Central Interceptor Scheme

Central Interceptor Main Project Works Section 92 Response Report to Auckland Council

Date 13 May 2013

MT ALBERT WAR MEMORIAL RESERVE CAR PARK - PERMANENT WORKS PLAN

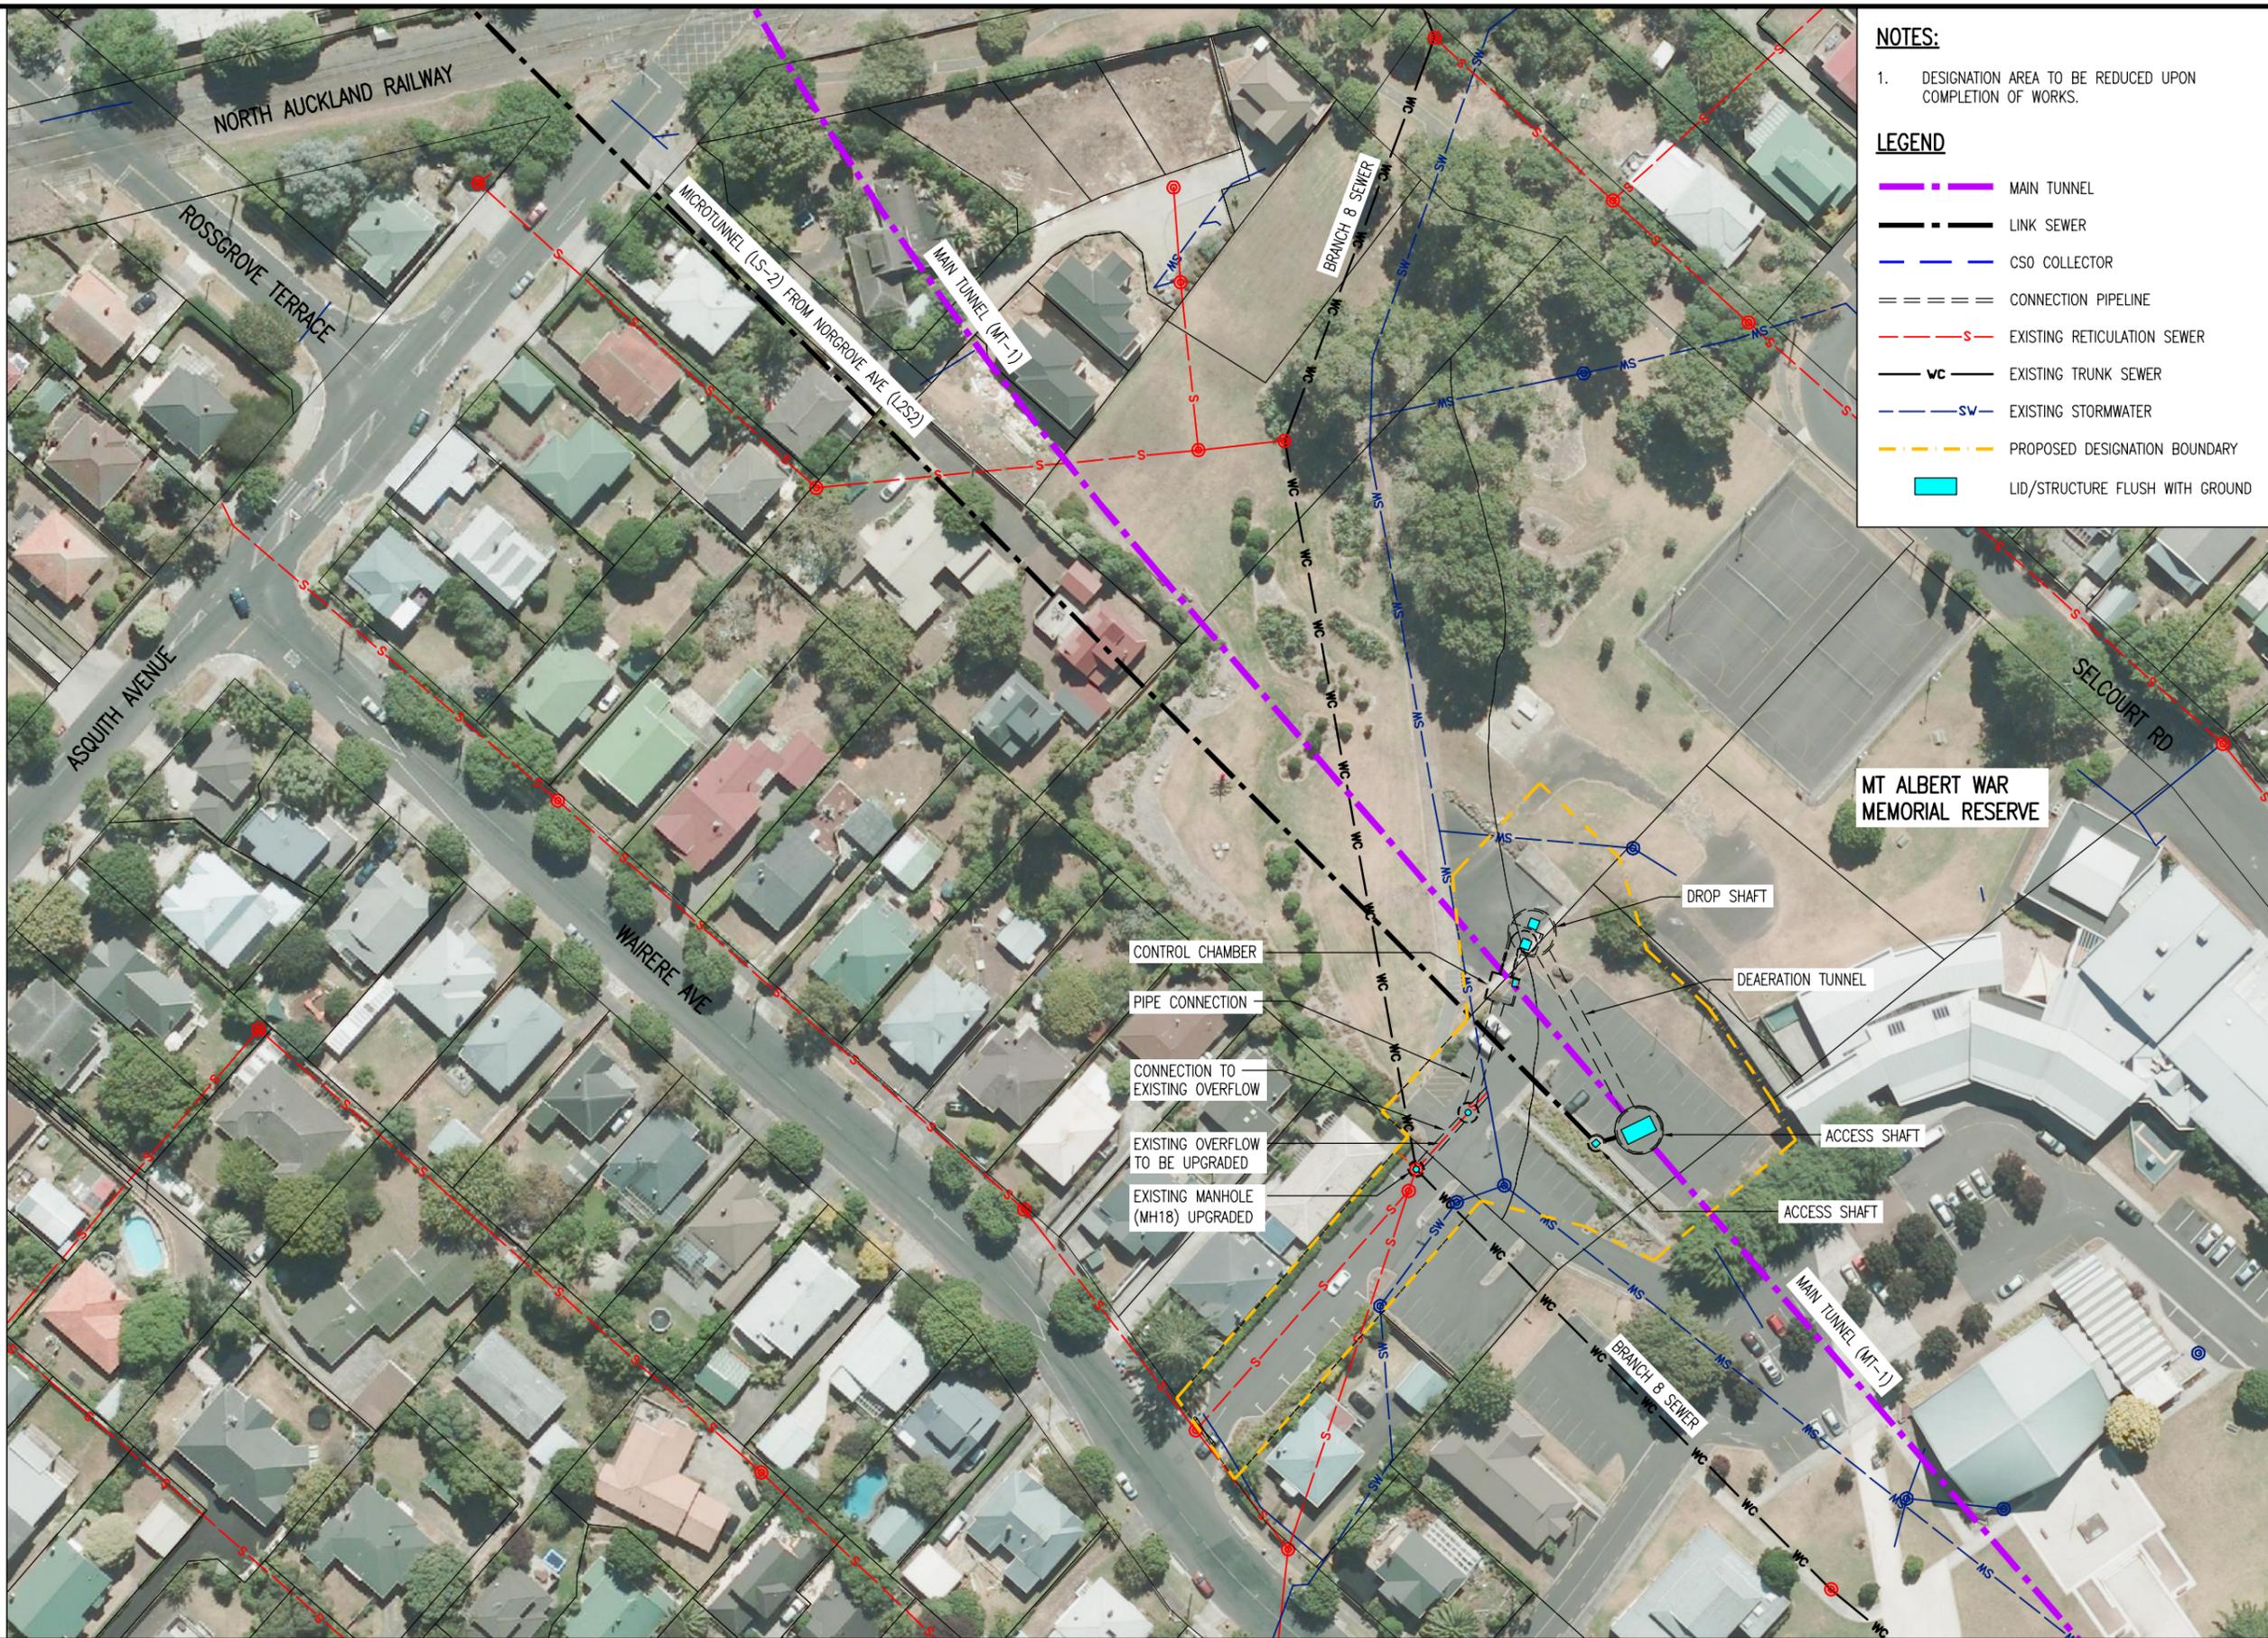
A revised site layout for the Mt Albert War Memorial Reserve Car Park site is attached (Drawing AEE-MAIN-2.1A Issue C and AEE-MAIN-2.2A Issue D, **Attachment 2**). This shows the control chamber located further to the north than the previous version. This revision to the site design has been taken into account in our responses to the noise and vibration questions in Part B of this report. The outcome of this revision is that the control chamber and associated construction works are shifted further from the boundary with 9 Wairere Avenue.

Watercare Central Interceptor
 May Road (WS2) - Car Tracking

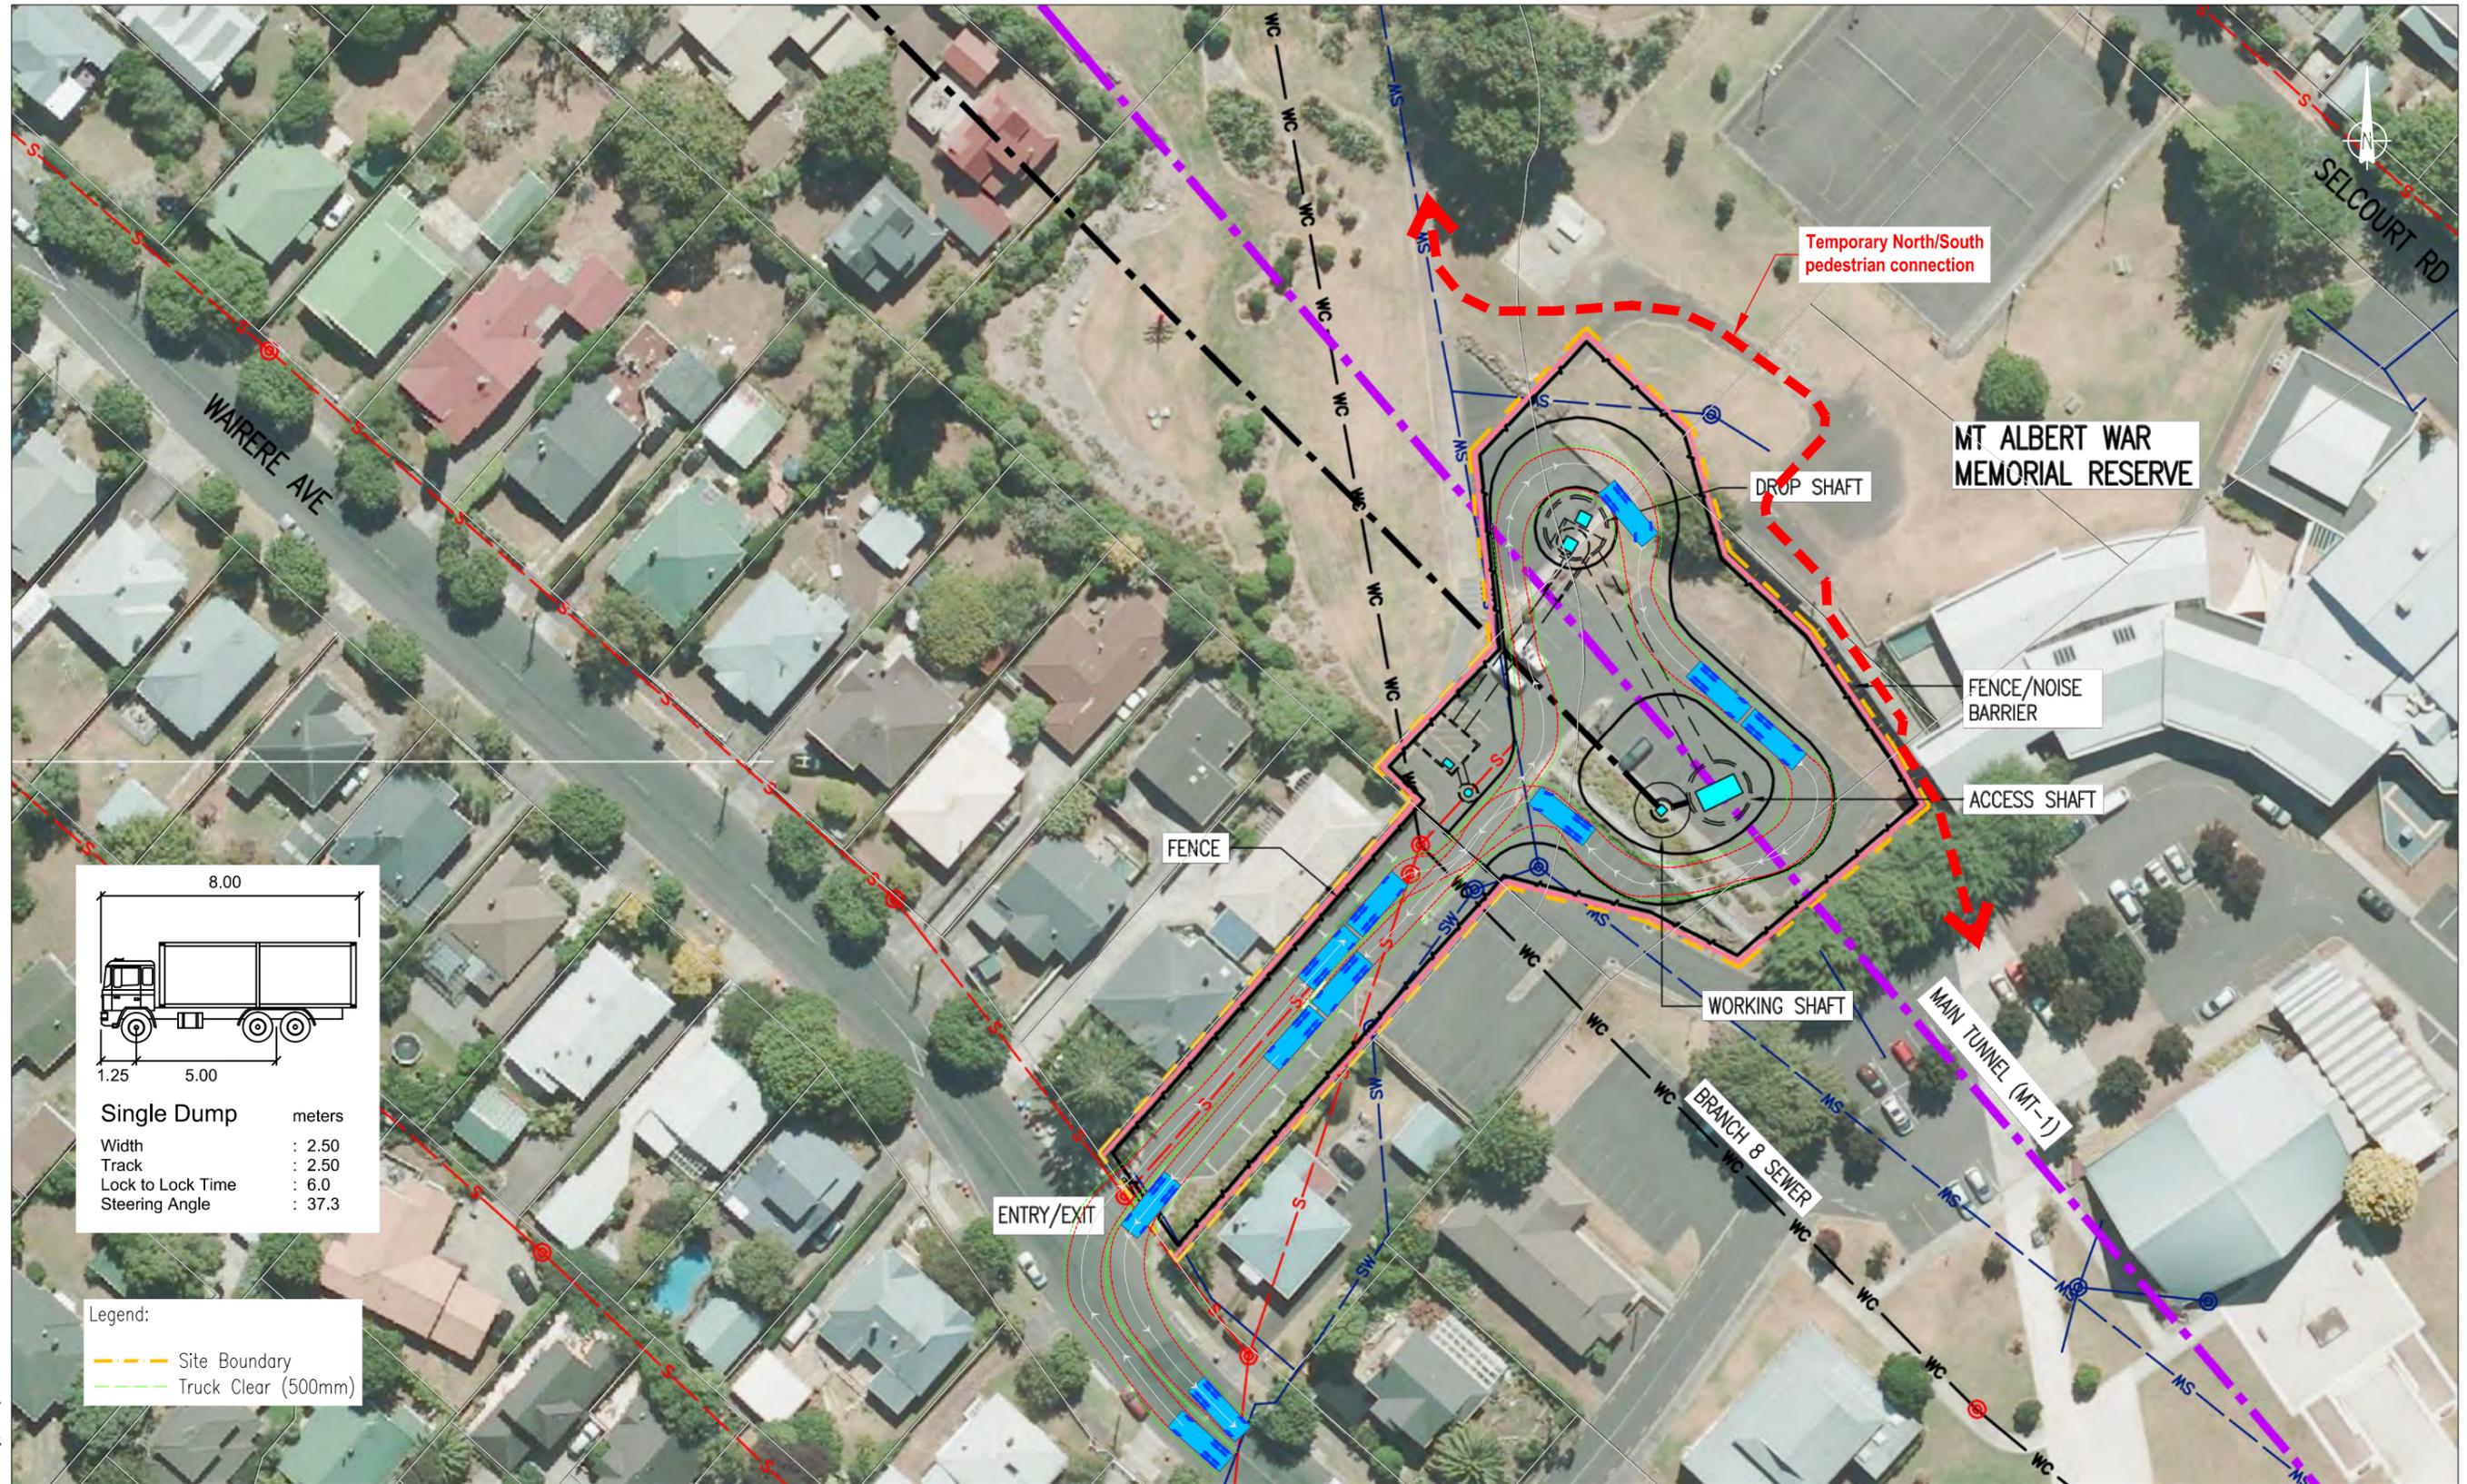
Figure 12b (attached) shows two-way car movement over the entire access. Given the site driveway will need to be around 7.5m in width to accommodate the truck tracking shown in Figure 12a included in Attachment 6 of December 2012 Section 92 Response Report (attached), two-way operation of cars will be easily achievable.

Watercare Central Interceptor
Mt Albert War Memorial Reserve Car Park (AS1) - Truck Tracking

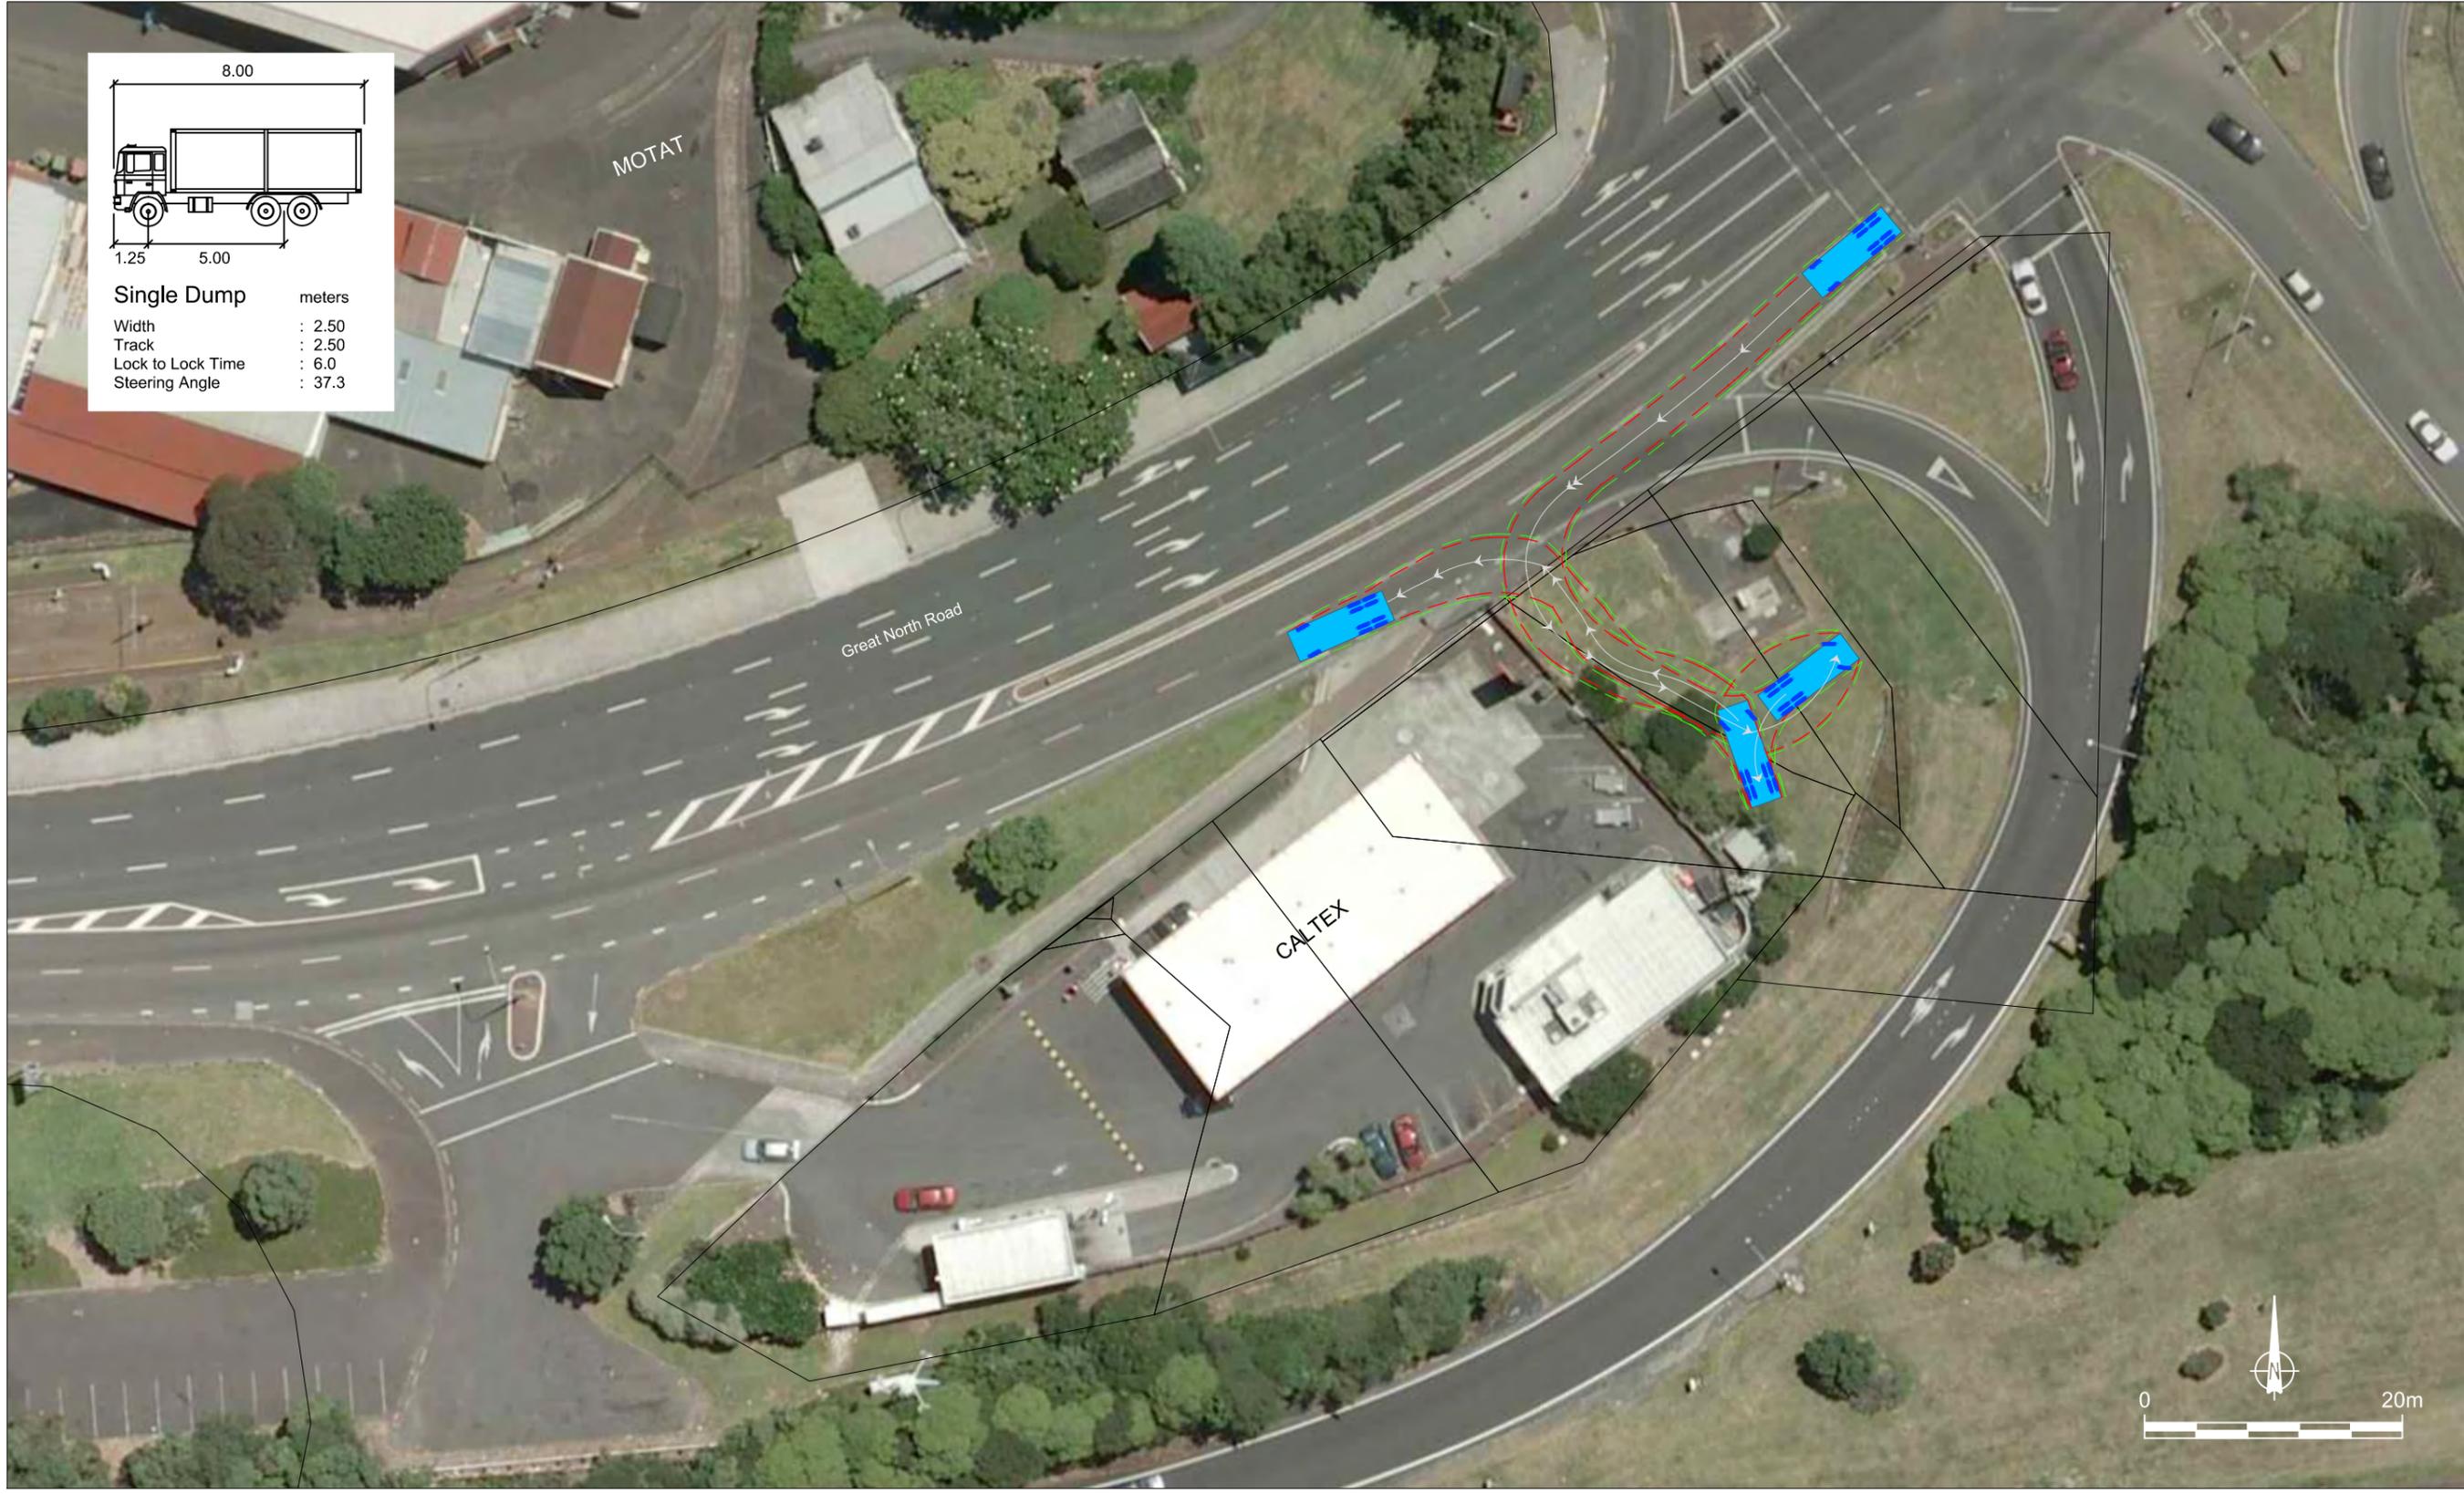
Given the length of time involved a manual controller will only likely be present when larger / one-off deliveries occur (likely with the semi-trailers also shown in the right window of Figure 12a), with the remainder of time generally being truck and trailer units (spoil removal, shown in the left window of Figure 12a).
